RECORD DWGS
AS FABRICATED

TOWN OF WARREN, VT
COUNTY OF WASHINGTON
BRIDGE NO.173 REPLACEMENT
WARREN, VT

DESIGN: SAF	DRAW: TLB	REVIEW: SAF/RL/L	CHECK: C/JG	SHEET 9s
SHOP DETAILS		PROFILES		51622

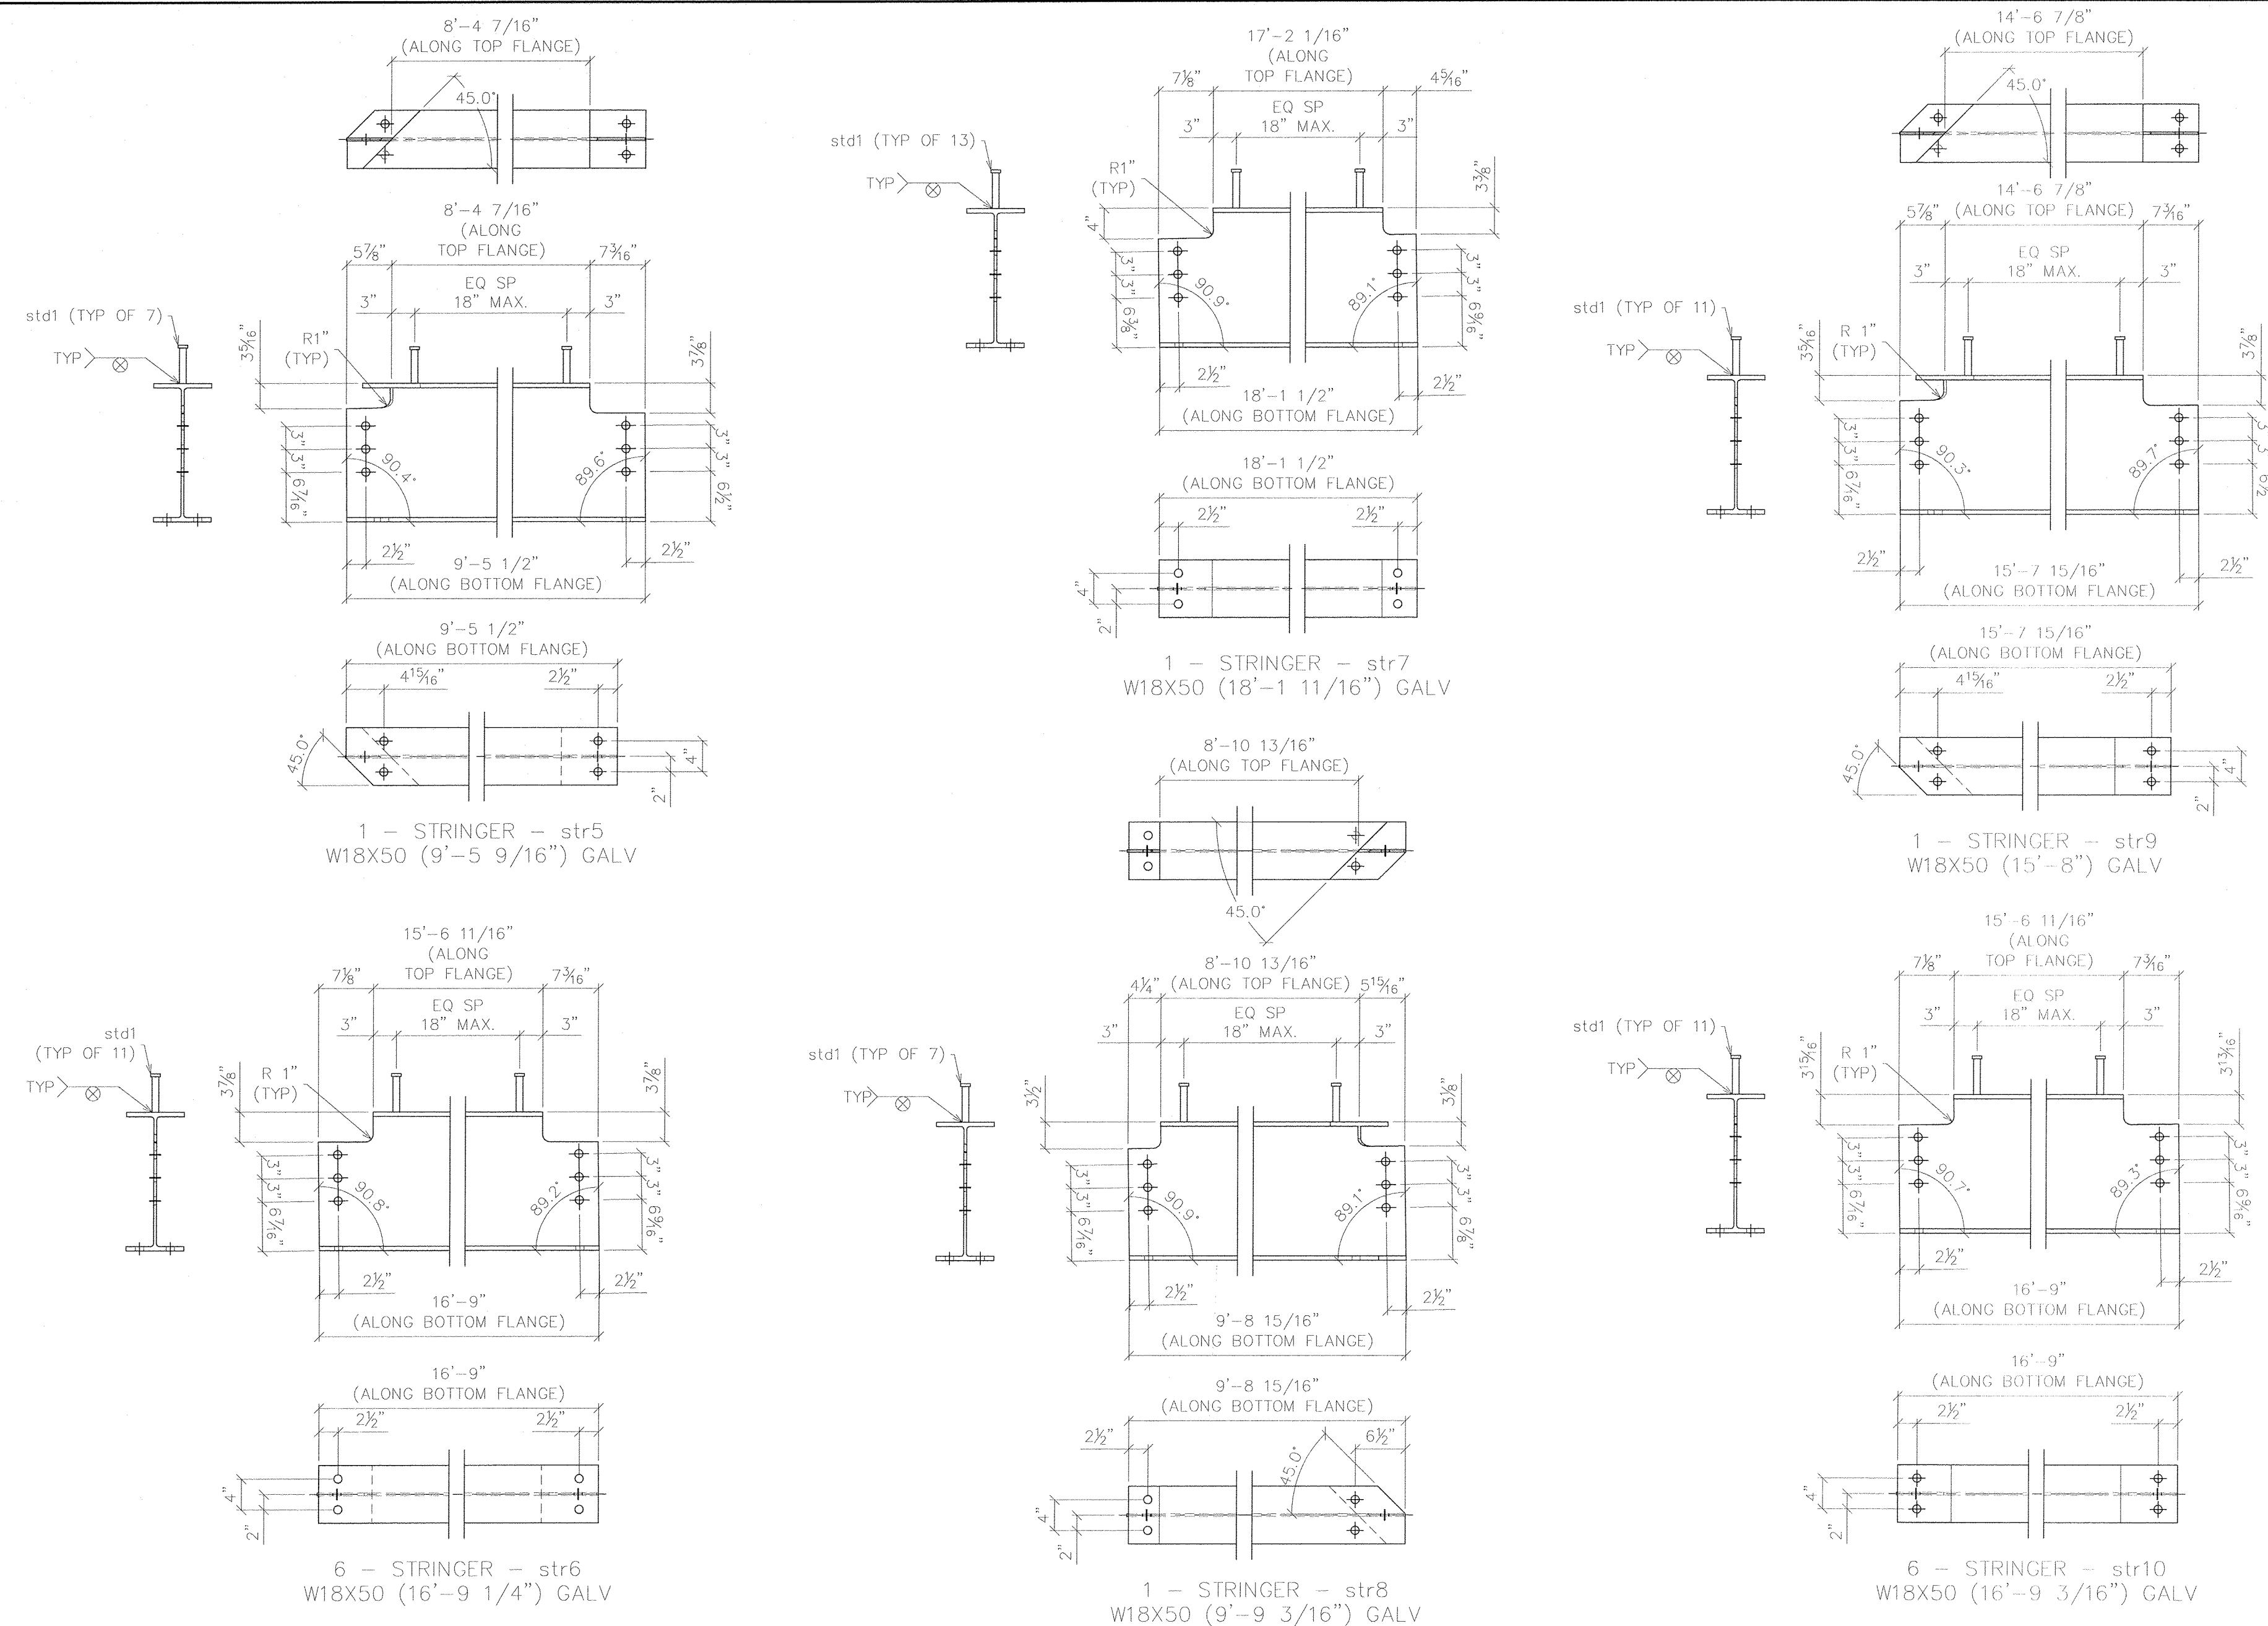
SUBMITTAL LOG	DATE	NO.	DATE	REVISIONS:	BY:
INITIAL SUBMITTAL	12/18/12	▲	5/15/13	FLOOR BEAM END PLATES WAS 1" THK	TLB
RESUBMITTAL NO. 2	2/5/13	▲	5/15/13	ADDED 2" DIA. RAT HOLES IN 1b1 & 1b9	TLB
CUSTOMER APPROVAL	2/13/13	▲	5/15/13	CHANGED WELD WAS 3/8" ALL AROUND	TLB
SHOP REVIEW	-	▲	5/15/13	CHANGED BOLT PATTERN	TLB
PRE FAB MTG	-	▲	5/15/13	WAS 2" EDGE DISTANCE	TLB
APPROVED FOR FAB	2/28/13	▲	6/3/13	DIMENSIONAL ERRORS	TLB
